## INSTRUCTION TO SERVICE

<b>ITS: 6385</b>	
<b>SECTION:</b>	241 Fuel System
<b>WRITTEN BY:</b>	Dwayne Peters
<b>SUBJECT:</b>	Replace Fuel Vent Lines and Pressure Relief Devices

**Figure 1: Vent lines affected in Section 1**

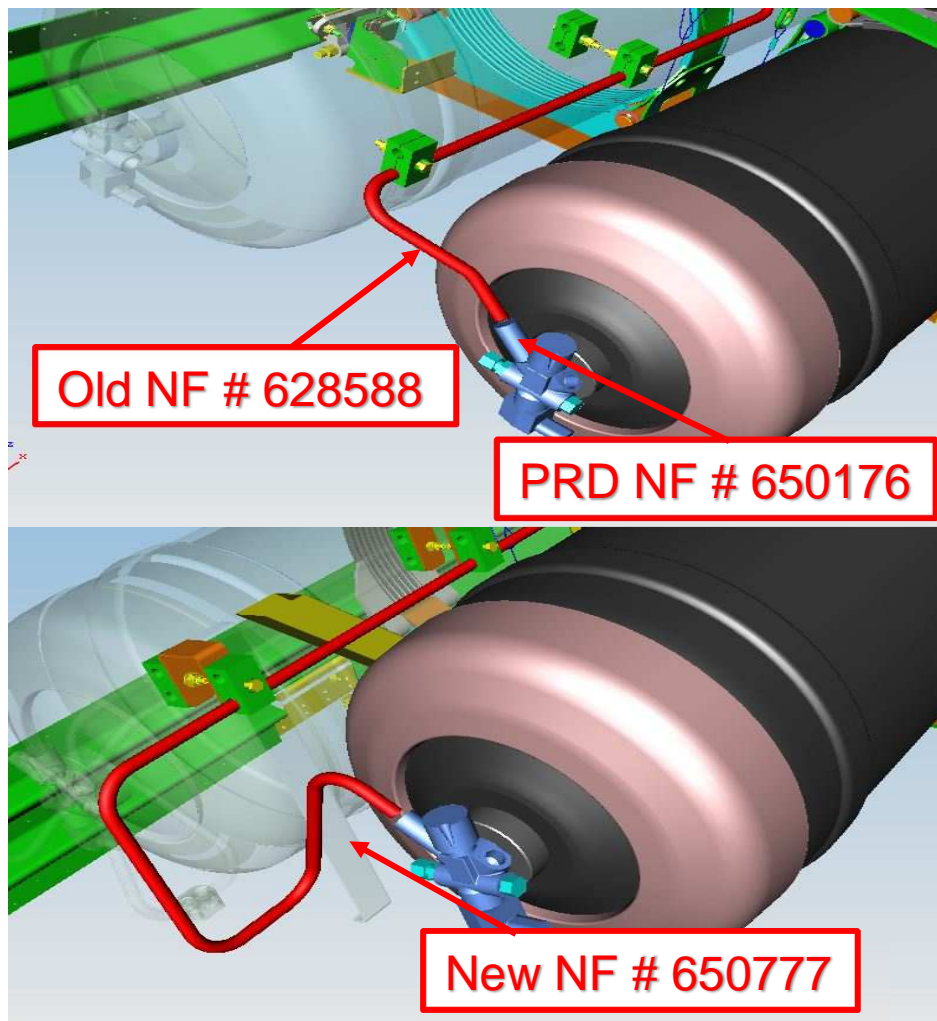
**SECTION 1: REPLACE THE OLD VENT LINE (NF # 628588) WITH A NEW VENT LINE (NF # 650777) AND REPLACE PRD (NF # 650176)**

Figure 1 shows the vent line that must be replaced in this section.

**Figure 4: Tank-mounted PRD and old vent line**

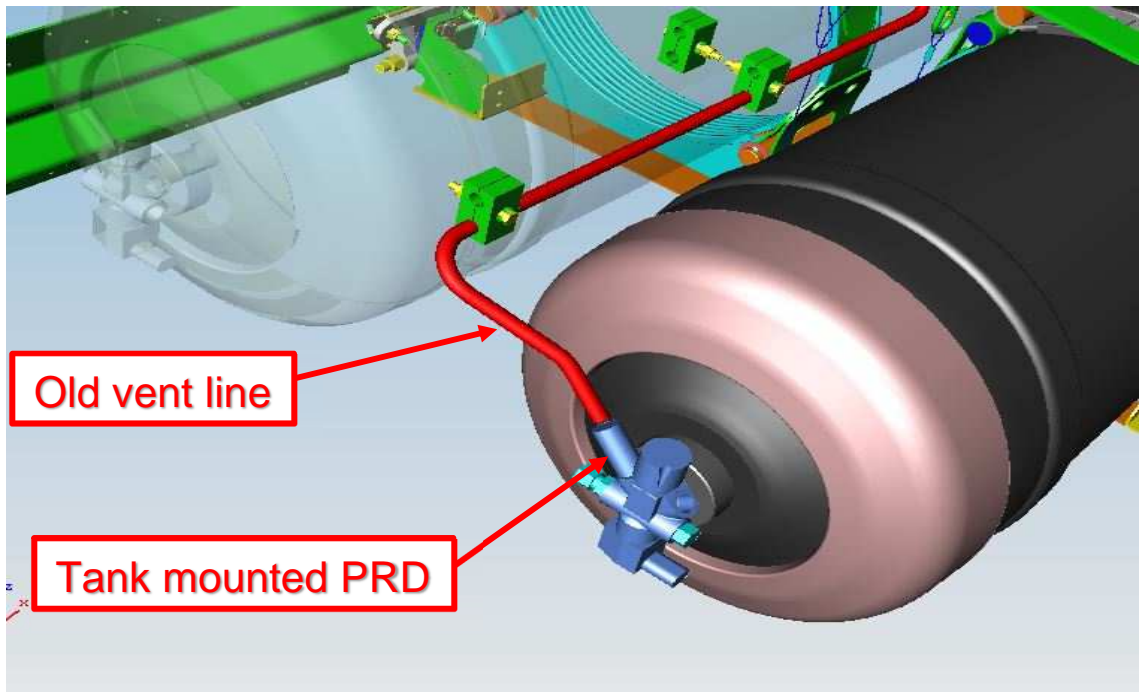
- Using a backing wrench to hold the adaptor body hex, disconnect the vent line from the tank-mounted PRD. Refer to Fig. 4.

Figure 6: PRD with adaptor

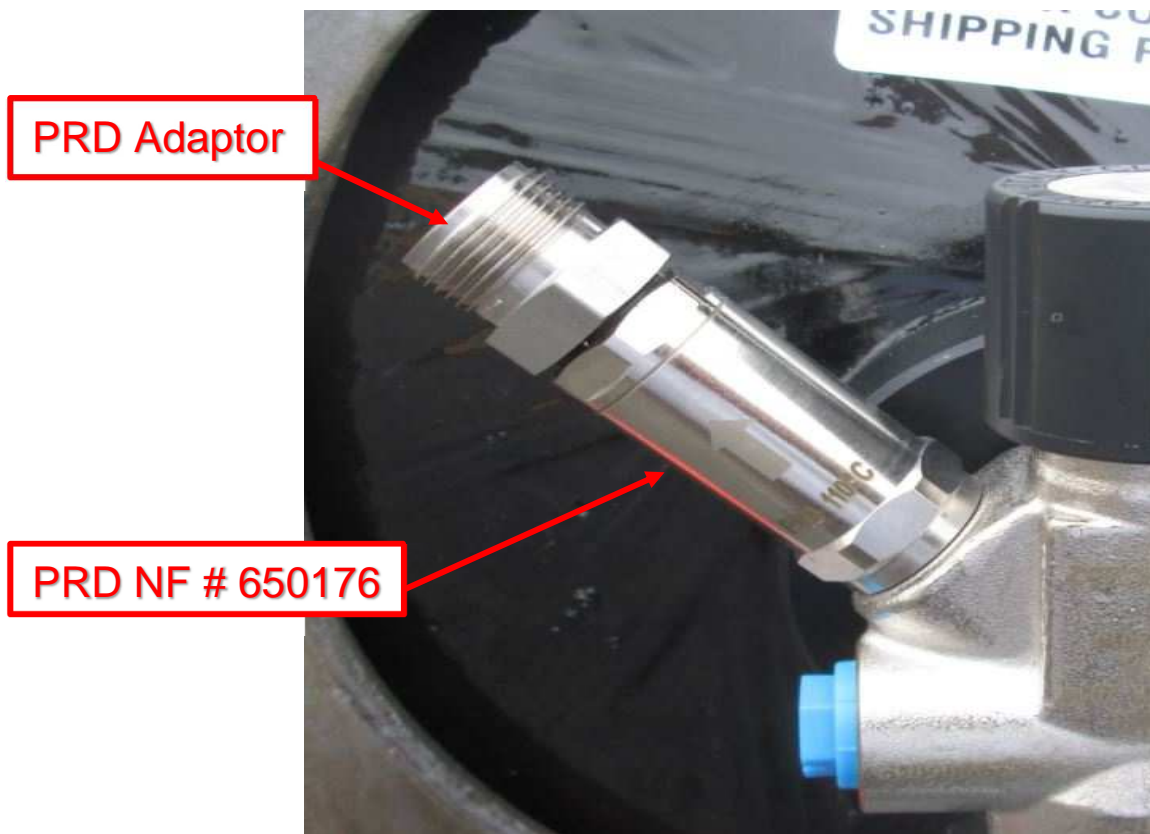
6. Remove and discard the affected vent line.
7. Remove and retain the tank-mounted PRD adaptor shown in Fig. 6. Discard the adaptor O-ring.
8. Remove, mark, disable, and discard the tank mounted PRD as described in the following note.

☞ **NOTE:** Paint the old PRD with orange paint and then destroy/damage the old PRD in such a way that it cannot be reused.

**Figure 7: PRD O-ring**

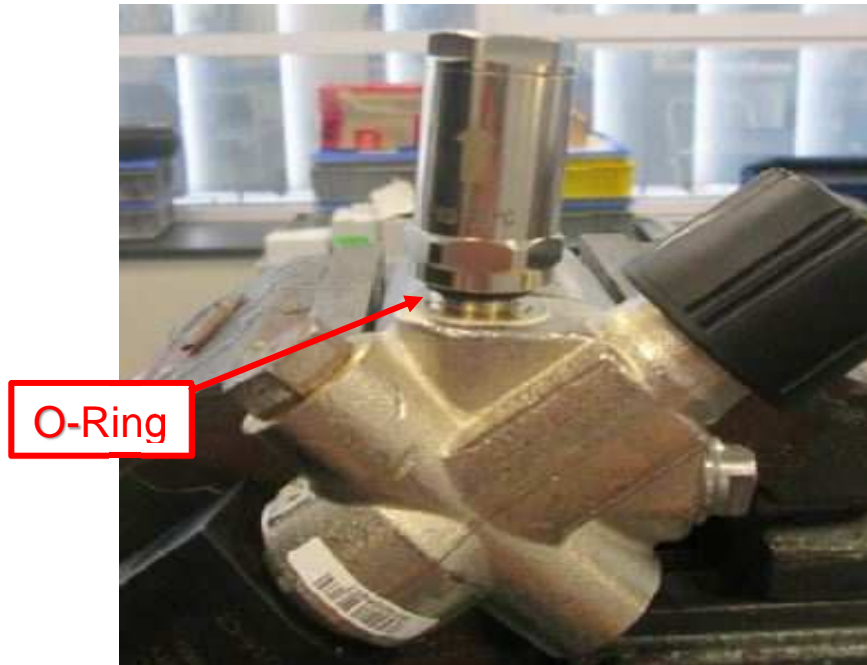
9. Apply grease sparingly (NF # 5945362) to the O-ring of the new PRD (NF # 650176) shown in Fig. 7. Do not apply any grease to the PRD threads. If any grease is on the threads, wipe off before installation.

☞ **NOTE:** The new PRD has a new O-ring installed. Under no circumstances should the old O-ring be reused from the old PRD.

**Figure 8: Torque PRD to 26 FT-LBS**

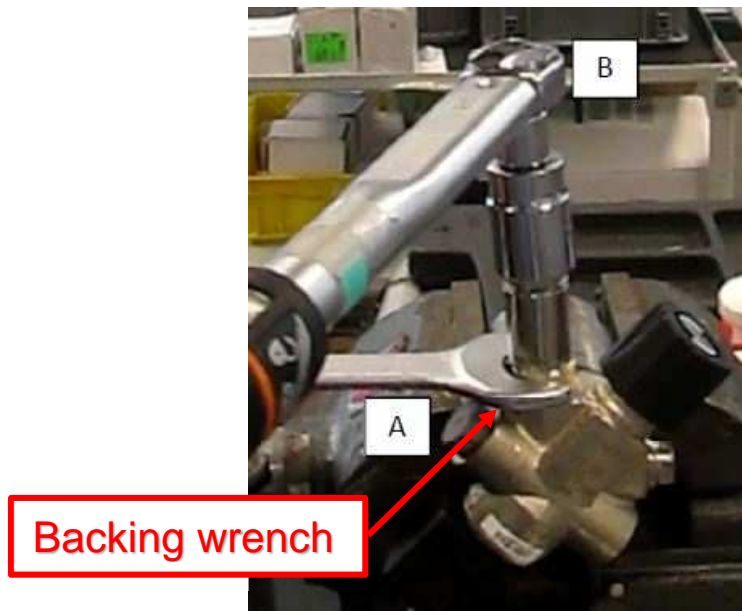
10. Install the new PRD and torque the top hex (3/4") to 26 FT-LBS. Refer to Fig. 8.

**Figure 9: Torque adaptor while using a backing wrench**

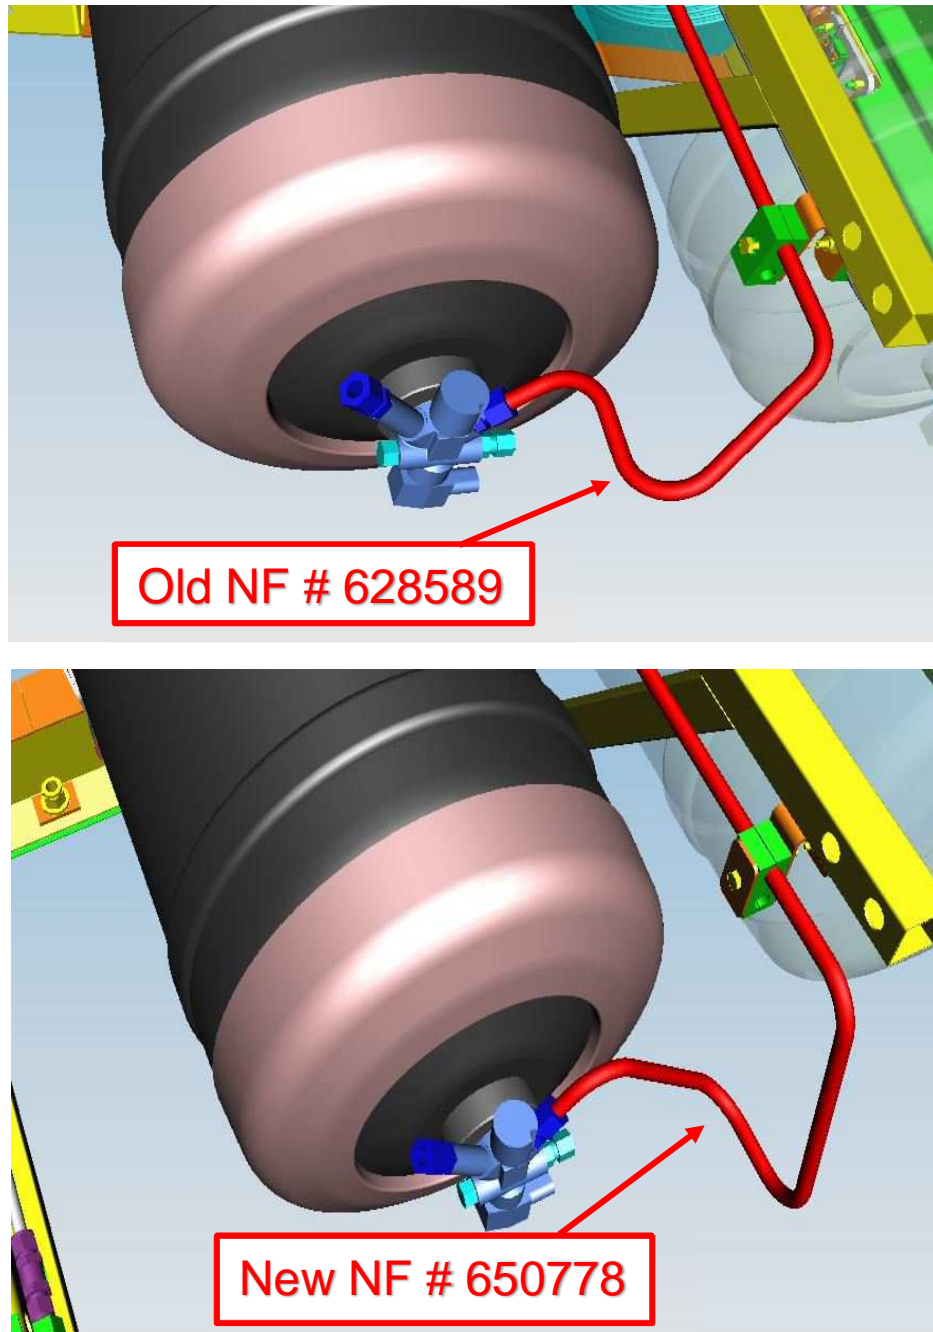
11. Install a new O-ring (NF # 116719) on the adapter fitting. Apply grease (NF #5945362) sparingly to O-ring. Do not apply grease to the threads. Wipe off any grease on the threads before installation.
12. Using a 13/16" backing wrench on the bottom hex of the PRD, torque the Swagelok adaptor fitting 30 to 37 FT-LBS. Refer to Fig. 9.

**Figure 13: Disconnect vent line from the adaptor on the solenoid valve**

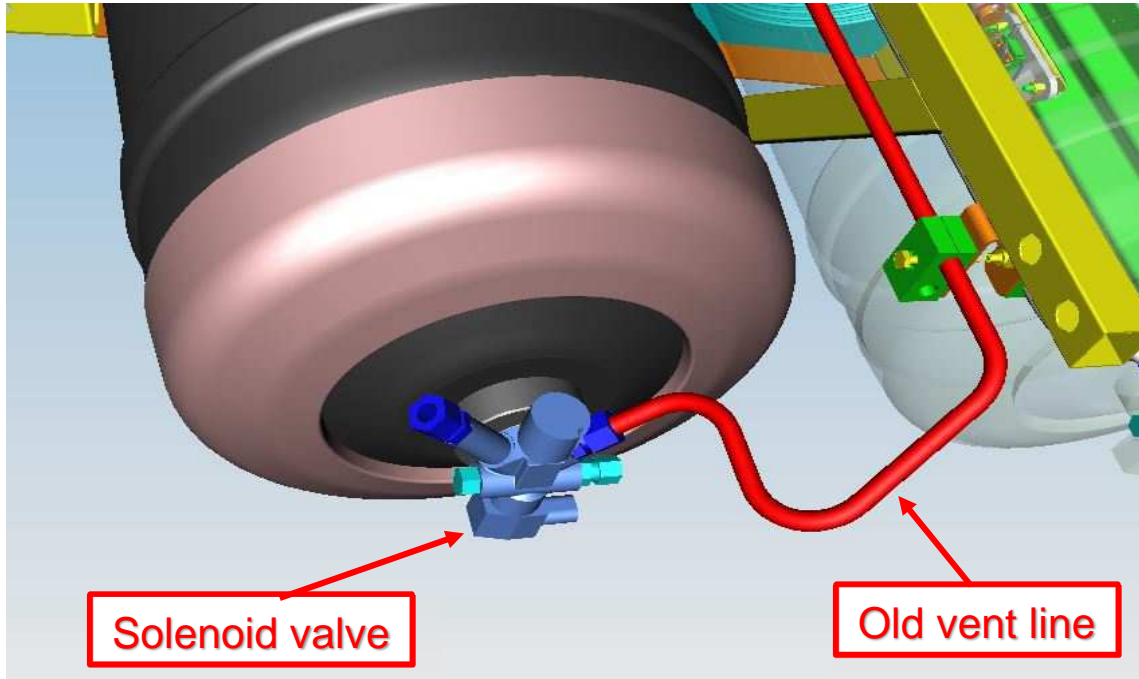
- Using a backing wrench to hold the adaptor, disconnect the vent line from the tank solenoid valve. The adaptor on the solenoid valve will remain in place. Refer to Fig. 13.
